UNITED STATES PATENT AND TRADEMARK OFFICE

APPLICATION NO.	FILING DATE	FIRST NAMED INVENTOR	ATTORNEY DOCKET NO.	CONFIRMATION NO.
10/727,739	12/04/2003	Robert T. Bigelow	BA-U-BLK-00010	4006
7590 Mr. Franklin E. Gibbs, Esq. Bigelow Aerospace 1899 W. Brooks Ave. North Las Vegas, NV 89032			EXAMINER PAINTER, BRANON C	
			ART UNIT 3609	PAPER NUMBER
			MAIL DATE 08/02/2007	DELIVERY MODE PAPER

Office Action Summary

DETAILED ACTION

Fig. 1

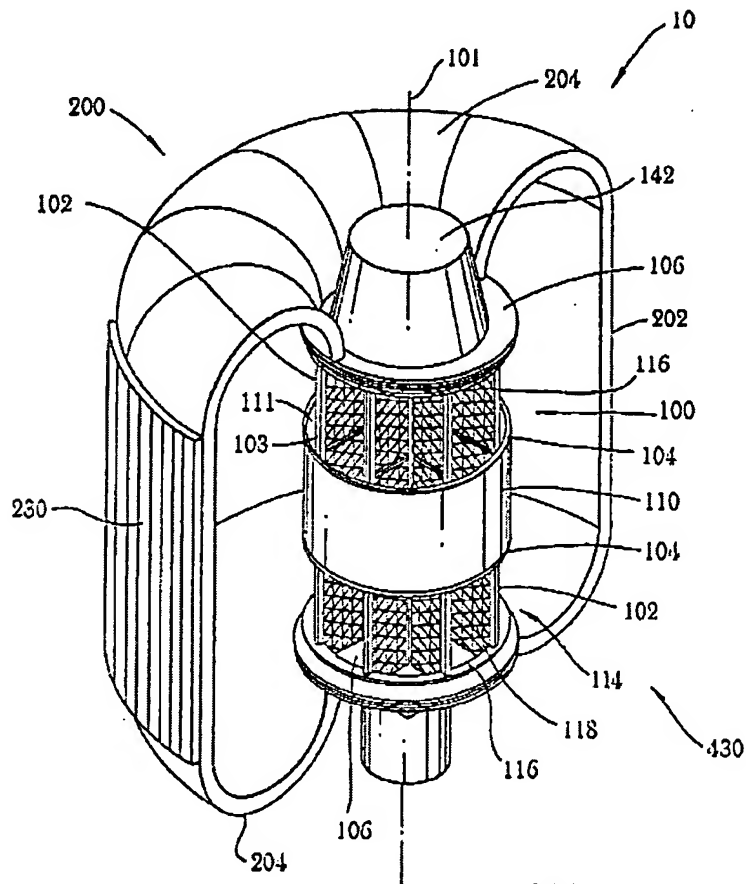
- a. "A bulkhead assembly...the inflatable modular structure having at least two longerons..." ("module" 10 with "longeron" 102, Fig. 1).
 - b. "...an inflatable bladder having an opening on opposite ends, and a flexible restraint layer having an opening on opposing ends and a plurality of attachment loops on either end..." ("inflatable shell" 200, Fig. 1, comprising "bladder" 211 and "structural restraint" 212, Fig. 14, and including structural restraint loops as seen in 212, Fig. 15).

- c. "...the bulkhead assembly comprising: a plate..." ("end ring" 116, Fig. 1).
 - d. "...means for securing the longerons to the plate..." ("Each of the two end rings 116 is fixedly attached, by means well known in the art such as welding or bolting,...to an end of each longeron 102," column 11, lines 20-23).

- a. Raboin et al. discloses an inflatable vessel including:
 - i. "A bulkhead assembly...the inflatable modular structure having at least two longerons..." ("module" 10 with "longeron" 102, Fig. 1).

Fig. 14

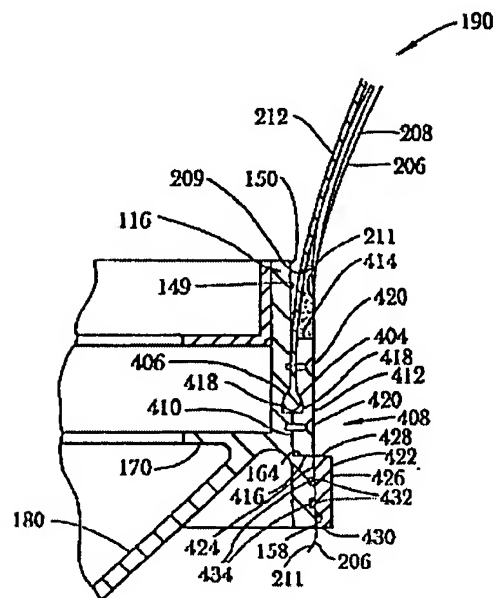
- e. "...means for securing one of the opposing ends of the inflatable bladder to the plate..." ("seal ring" 422, Fig. 14; "The thicker single bladder 211 is also sealingly constrained between the secondary end ring area 158 of each end ring 116 and seal ring 422," column 14, lines 48-52).

- v. "...a first bladder flange..." ("deadman retainer" 408, Fig. 14).
- vi. "...a second bladder flange..." ("seal ring" 422, Fig. 14).
- vii. "...a plurality of flange seals..." ("seals" 432, Fig. 14).

- viii. "...the first and second bladder flanges adapted to securedly receive one of the opposing ends of the inflatable bladder therebetween..." (flanges receive "bladder" 211, Fig. 14).

- ix. "...the second bladder flange being secured to the inner surface of the plate with a plurality of flange seals secured between the plate and the second bladder flange..." ("seals" 432, Fig. 14).

Fig. 15

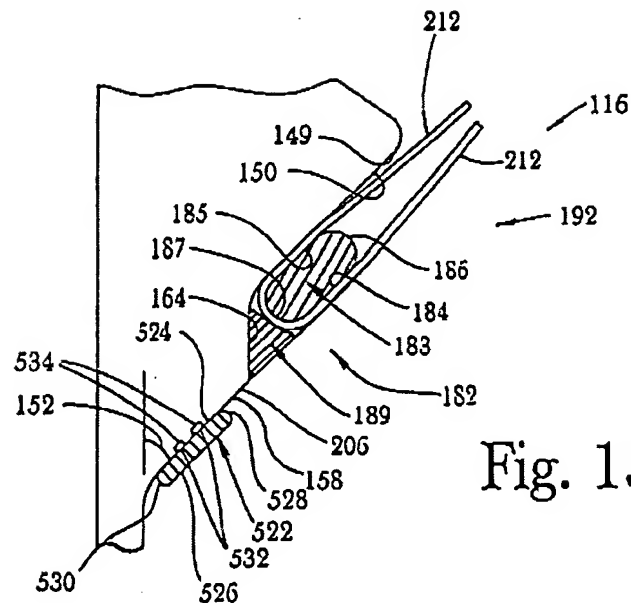
- f. "...means for securing the attachment loops on one of the opposing ends of the flexible restraint layer to the plate." ("attachment ring" 182, Fig. 15; "Attached to structural restraint 212 as previously disclosed, each attachment

ring 182 is fixedly connected, by means well-known in the art such as bolting, to one of the end rings 116," column 15, lines 39-42).

restraint layer such that the layer substantially encompasses the bladder.” (loop shown in Fig. 15; the same “structural restraint” 212 is shown encompassing “bladder” 211 in Fig. 14).

Reproduced from U.S. Patent No. 6,442,903 (Amended by Examiner to Highlight Details)

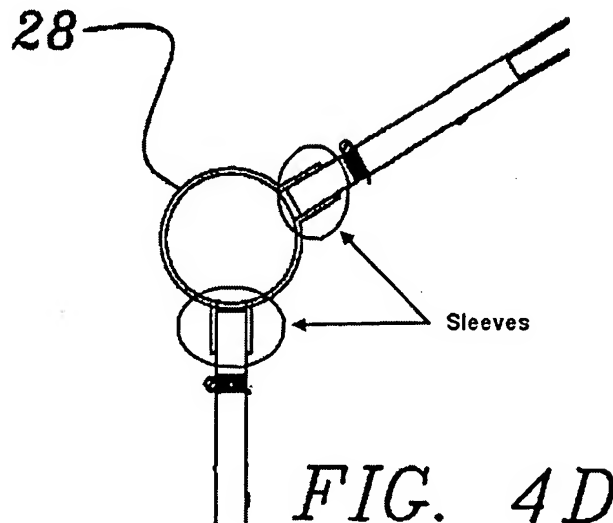
- c. Hebert discloses two longeron sleeves, each fixedly secured to a plate and adapted to receive a longeron (“air distribution header” 28 with attached “sleeves”, amended Fig. 4D). The use of longeron sleeves as taught by Hebert allows longerons to be easily secured without the need for fasteners, welding, etc.

- e. Raboin et al. and Hebert are analogous art because both are from the field of endeavor of inflatable apparatuses.
- f. At the time of the invention, it would have been obvious to a person of ordinary skill in the art to modify the end rings of Raboin et al. by attaching longeron sleeves as taught by Hebert, in order to ease the longeron

Fig. 3

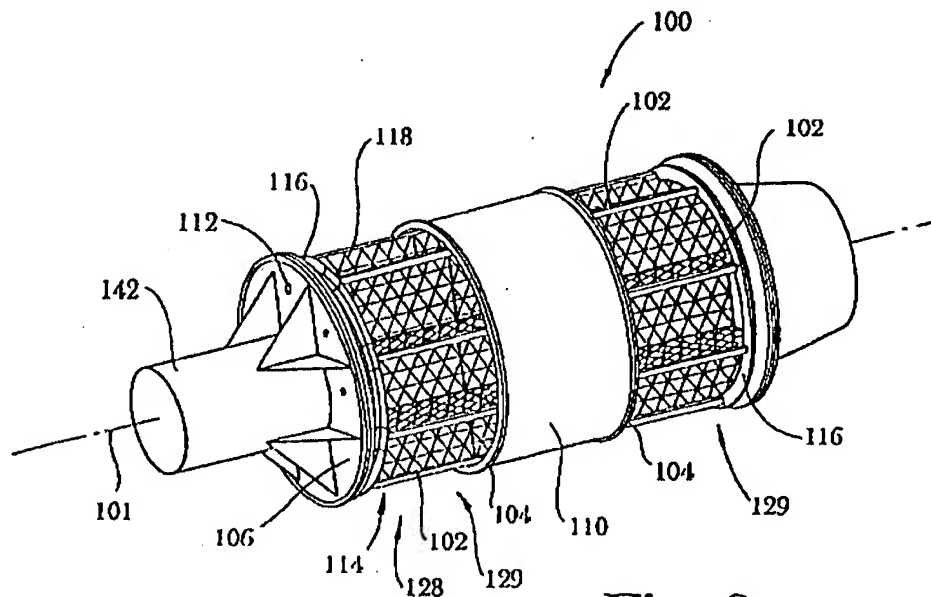
- a. Raboin et al. discloses an inflatable vessel as applied to claim 1 above, further including a separate plate with access holes ("endplate" 106 with "pass-through holes" 112, Fig. 3).
- b. Raboin et al. does not expressly disclose an access opening in the end ring 116.

- c. It would have been obvious to one of ordinary skill in the art to modify the end rings of Raboin et al. to include pass-through holes as also taught by Raboin et al.

- a. Raboin et al. discloses an inflatable vessel as applied to claim 1 above, and further including a plate with an outer surface adapted to receive an airlock or distal end assembly ("airlock" 142, Fig. 3).
